**Project  
T10/1683-D**

**Information technology -  
SCSI Architecture Model - 4 (SAM-4)**

**Summary of Comments on SCSI Architecture Model - 4**

Figure 1 — Requirements precedence

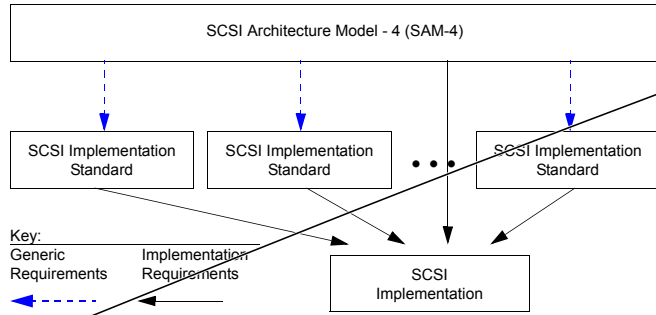
Author: Mark Evans, WDC Subject: Highlight Date: 10/25/2007 1:01:53 PM  
 Since text takes precedence in this standard, and text should introduce figures, tables, etc., I recommend moving the following paragraph above figure 1.

Status George Penokie Accepted 10/26/2007 2:31:33 PM  
 Author: Mark Evans, WDC Subject: Note Date: 10/25/2007 1:03:15 PM  
 I recommend that at least one "e.g." be added either in the four rows in figure 2, in the descriptive text that follows, or both. See SBC-3 for an example.

Figure 2 — SCSI document structure

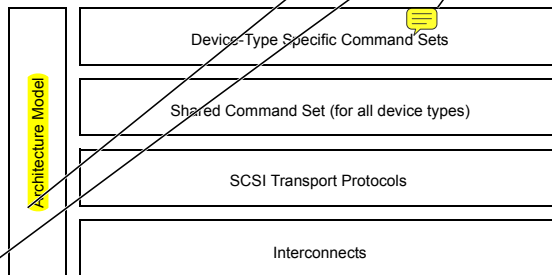
Status George Penokie Accepted 10/29/2007 3:50:40 PM  
 Author: Emulex Subject: Highlight Date: 10/30/2007 1:16:34 PM  
 Emulex-001  
 Page: 2 first sentence below Figure 2 - "roadmap" s/b "document structure"

Status George Penokie Rejected 10/29/2007 4:06:27 PM  
 Author: George Penokie Subject: Note Date: 10/26/2007 2:33:21 PM  
 Copied the SBC-3 figure into SAM-4.

Figure 4 — Notation for association relationships for class diagrams

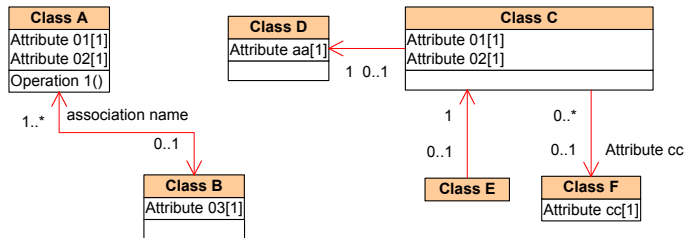
Author: Mark Evans, WDC Subject: Highlight Date: 10/29/2007 1:19:21 PM  
 \*Solid lines with arrowheads (see figure 4) are the notation...  
 sld  
 "...is the notation..." ["notation" meaning, "...any particular system of characters or symbols used to briefly express elements...", and this is my first choice]  
 or  
 "...are the notations..." ["notations" meaning, "...the characters or symbols used in such a system..."]  
 One way or the other, the verb has to agree with the object (i.e., either "is the notation" or "are the notations").  
 Status  
 George Penokie Accepted 10/29/2007 10:25:26 AM  
 Author: George Penokie Subject: Note Date: 10/29/2007 10:25:18 AM  
 Changed to "is the notation"

Figure 5 — Notation for aggregation relationships for class diagrams

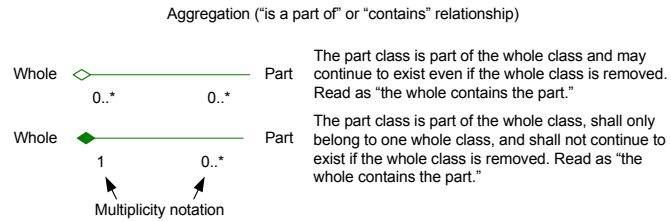
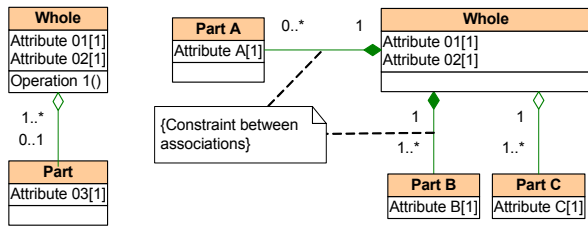
Author: Mark Evans, WDC Subject: Highlight Date: 10/29/2007 1:18:53 PM  
 \*Solid lines with diamonds (see figure 5) are the notation...  
 s/b  
 \*...is the notation... [see my earlier comment]  
 Status  
 George Penokie Accepted 10/29/2007 10:26:15 AM

Figure 12 — SCSI client-server model

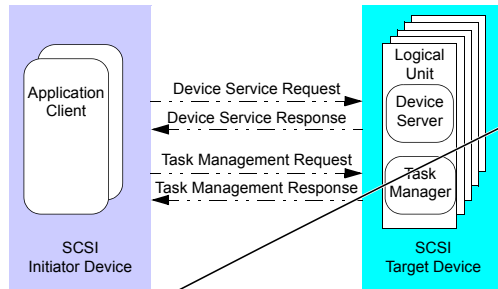
- Author: relliott Subject: Note Date: 10/28/2007 10:37:45 PM  
The last paragraph in 4.3.1 discusses commands and device server requests. It should also discuss TMFs and task management requests, to cover everything shown in figure 12.

Figure 15 — SCSI Domain class diagram

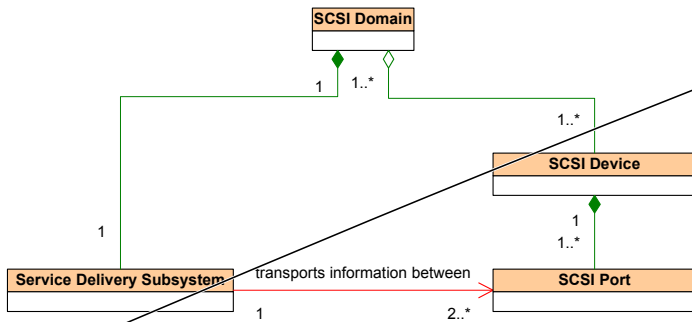
Author: relliott Subject: Highlight Date: 10/8/2007 6:53:52 PM  
 SCSI Domain class (figure 15)  
 s/o  
 SCSI Domain class (see figure 15)

Author: Mark Evans, WDC Subject: Highlight Date: 10/29/2007 1:21:01 PM  
 Each instance of a SCSI Domain class shall contain the following objects:  
 a) one service delivery subsystem;  
 b) one or more SCSI devices; and  
 c) one or more SCSI ports.  
 I think there shall be two or more SCSI devices and two or more SCSI ports, as shown in figure 16.

Status George Penokie Accepted 10/30/2007 3:42:44 PM

Figure 19 — SCSI Initiator Device class diagram

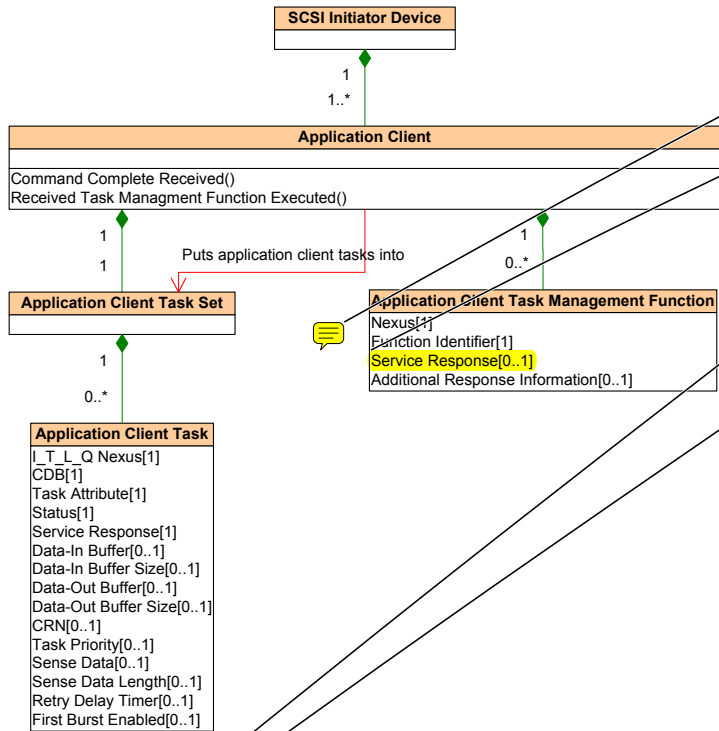
Author: reilott Subject: Note Date: 10/8/2007 6:53:04 PM  
 Nexus and Function Identifier should be swapped in figure 19 and in sections 4.5.11.2 and 4.5.11.3 to match the SCSI Target Device side in figure 22 and following sections. (or the target side should be swapped to follow this)

Figure 22 — Logical Unit class diagram

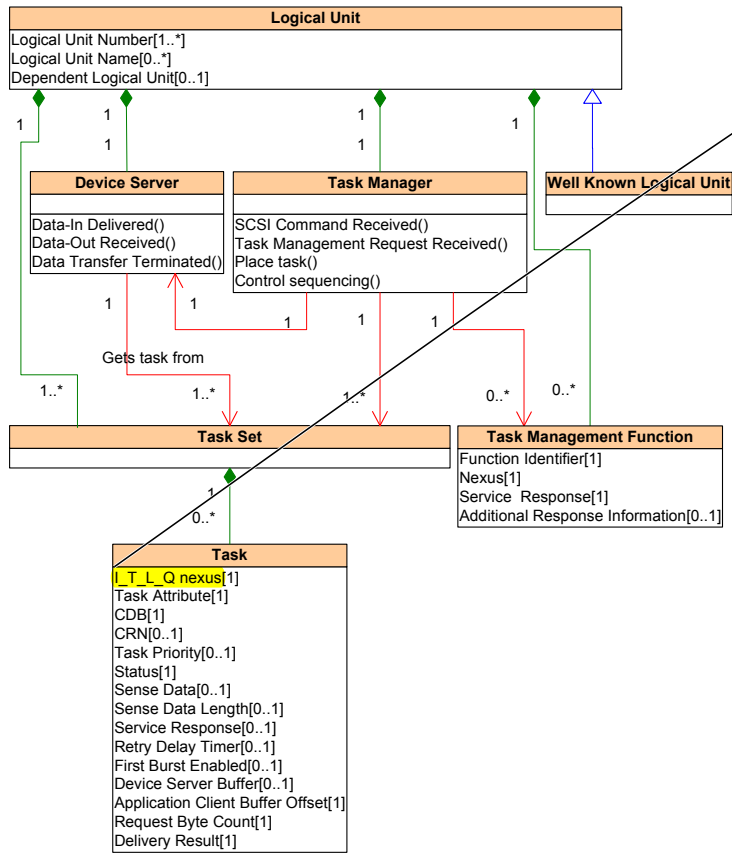
There is no class with that name, and it doesn't appear in figure 22.

Author: relliott Subject: Highlight Date: 10/8/2007 6:46:29 PM  
4.5.24.3 should be swapped with 4.5.24.2 to match the order the attributes are listed in figure 22.

Figure 4 — Notation for association relationships for class diagrams

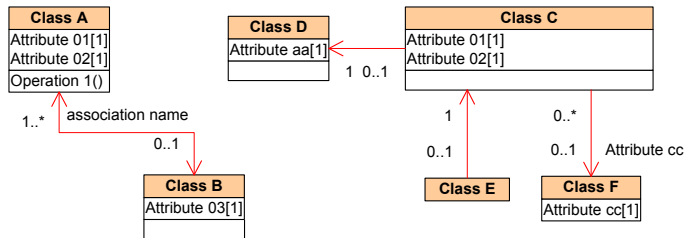
"is" is very awkward given that all the nouns on the left are plural.  
Restructure as  
\*The notation used to describe the association relationship between classes in class diagrams is solid lines with arrowheads (see figure 4).  
Apply to all the figure introductions in this section.
